PLANNING COMMISSION AGENDA

PUBLIC HEARING: Variance to increase the maximum front yard building setback; and Site Plan Review for Dayton Assisted Living, 136XX Balsam Lane N., PID: 14-120-22-41-0005

To:	Jon Sevald, Planning	From:	Jason Quisberg, Engineering Nick Findley, Engineering Ben Otto, Engineering
Project:	Dayton Assisted Living	Date:	4/30/2026

L100 LANDSCAPE PLAN

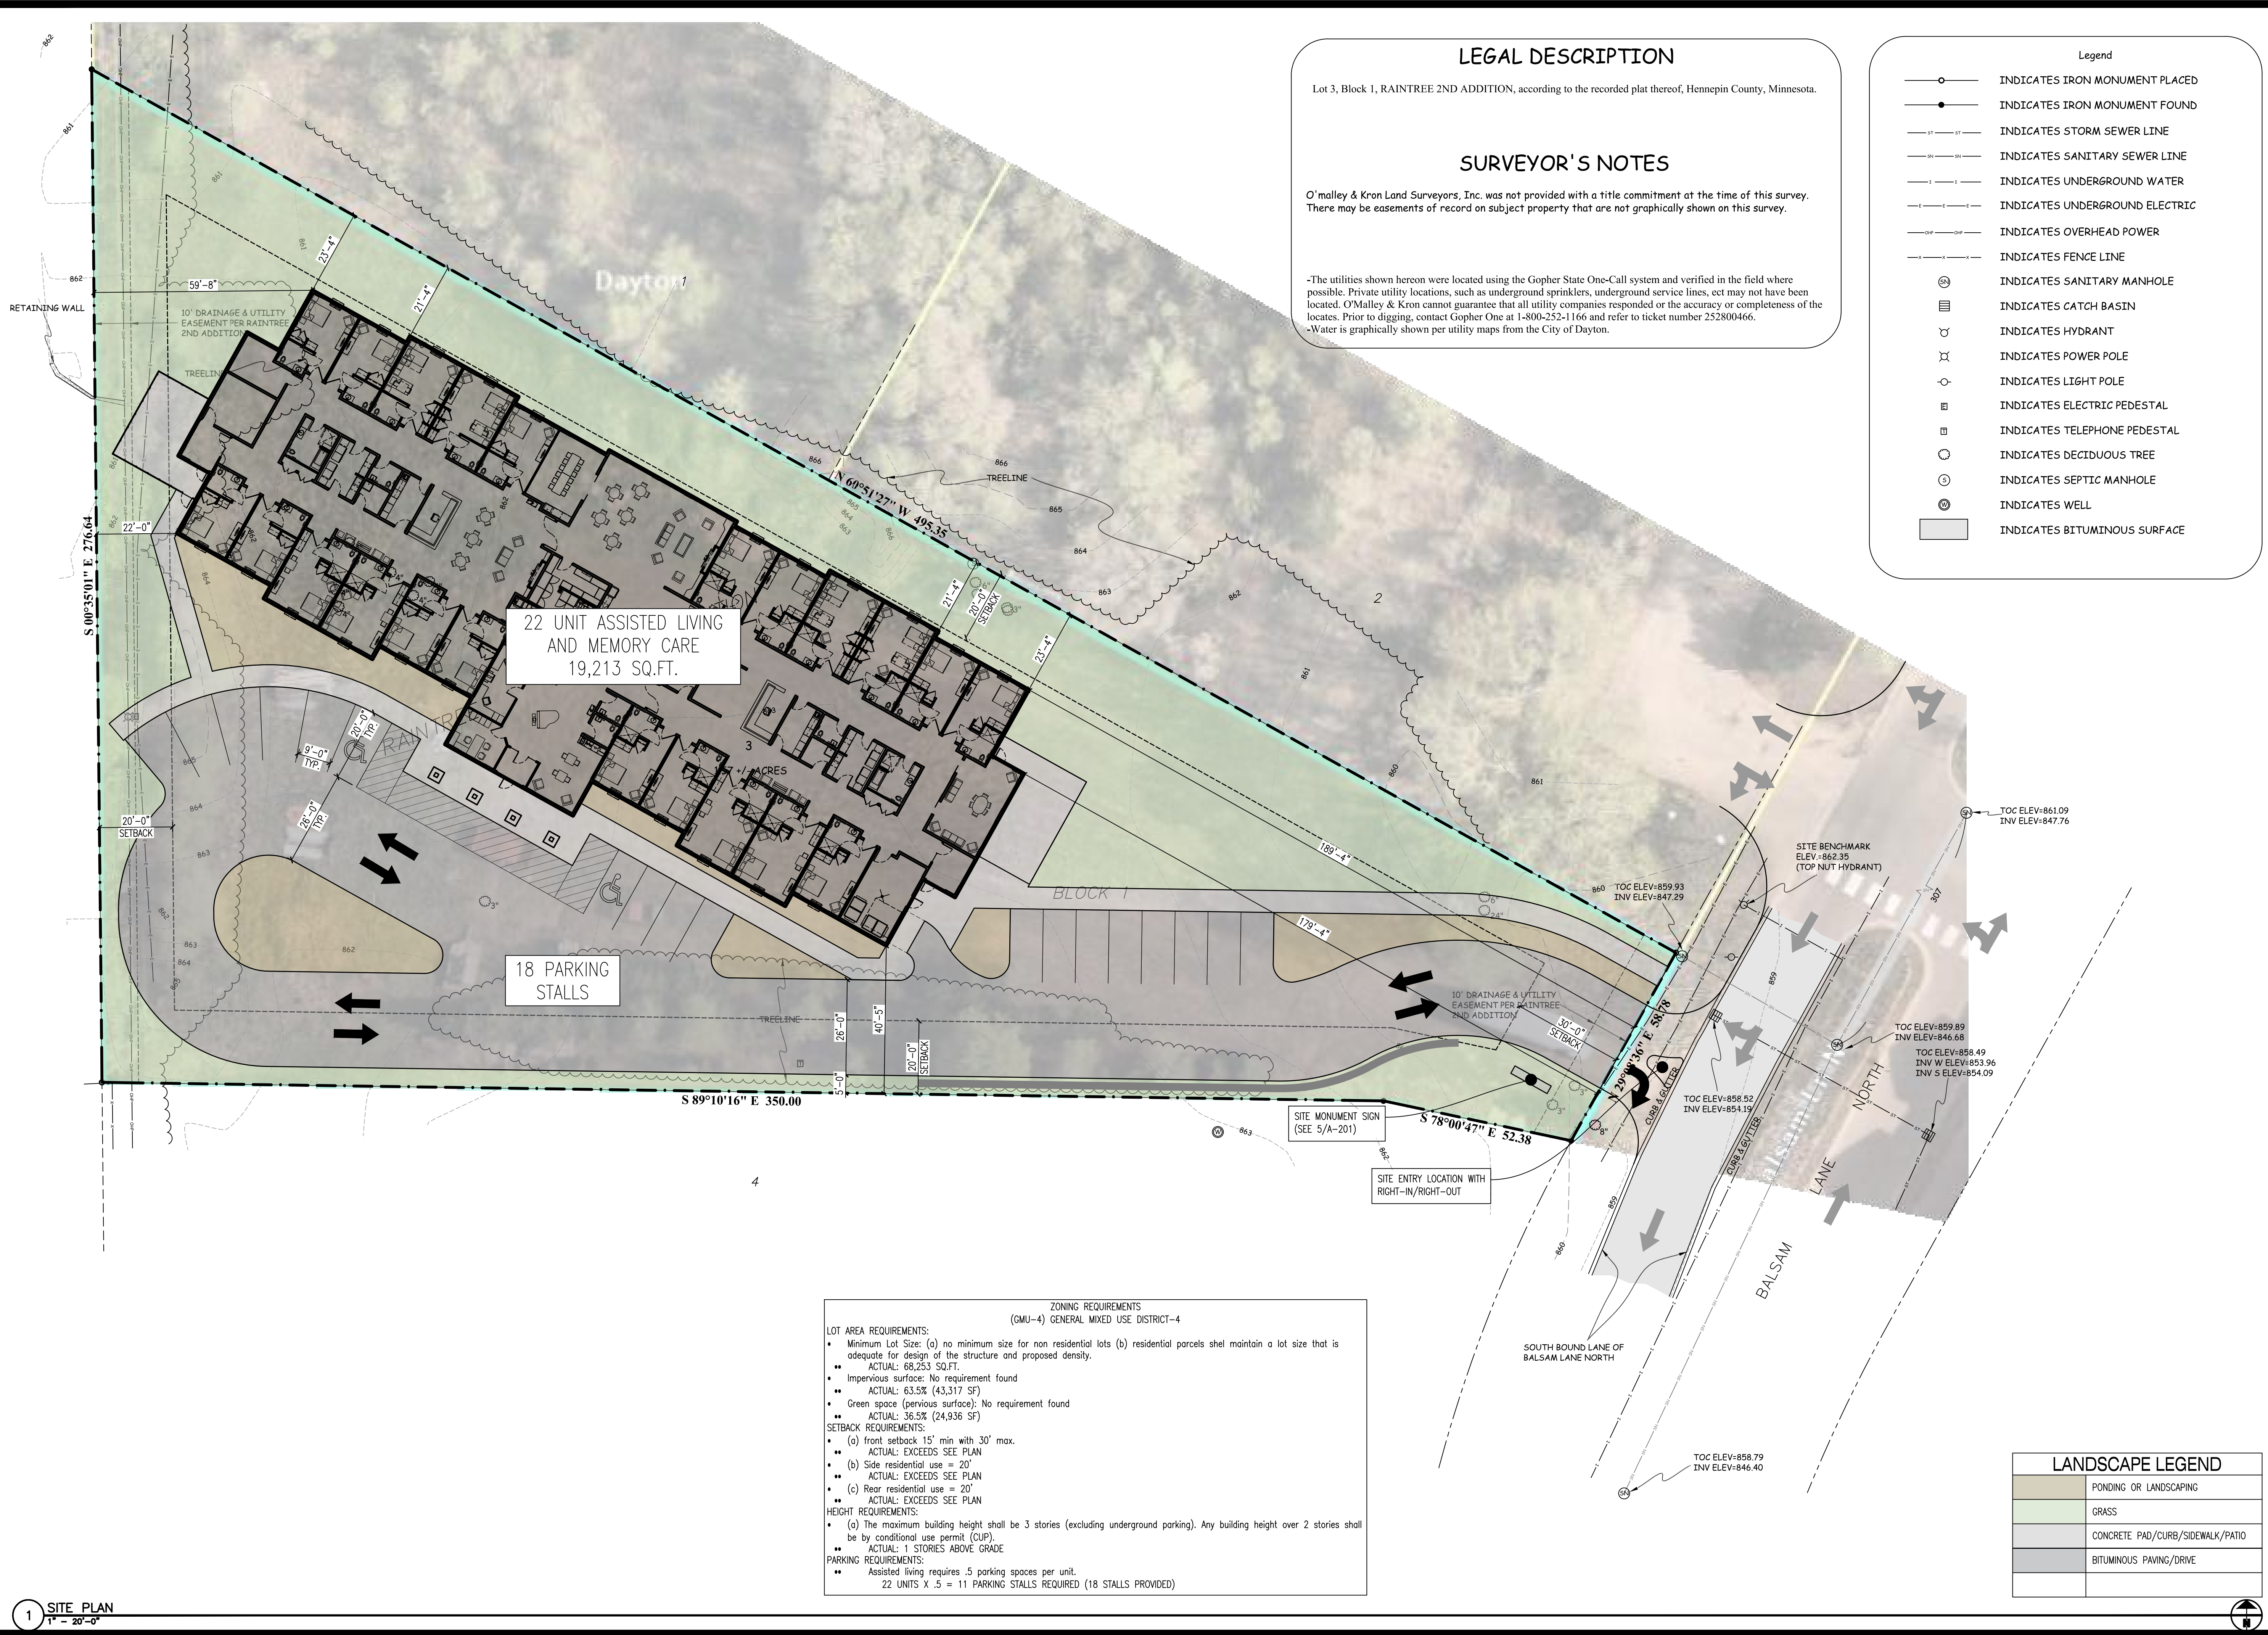
The number of plantings meets the intent of the City Code. If the Commission/Council recommends additional trees, there is space along the north property line in place of the Fire Lane.

42. The landscaping plan conflicts with the site plan, specifically related to the fire access route. Ensure consistency between the two plans.

Plans to be amended to add a 5' strip of ground cover along the building edge (in place of the north Fire Lane).¹¹
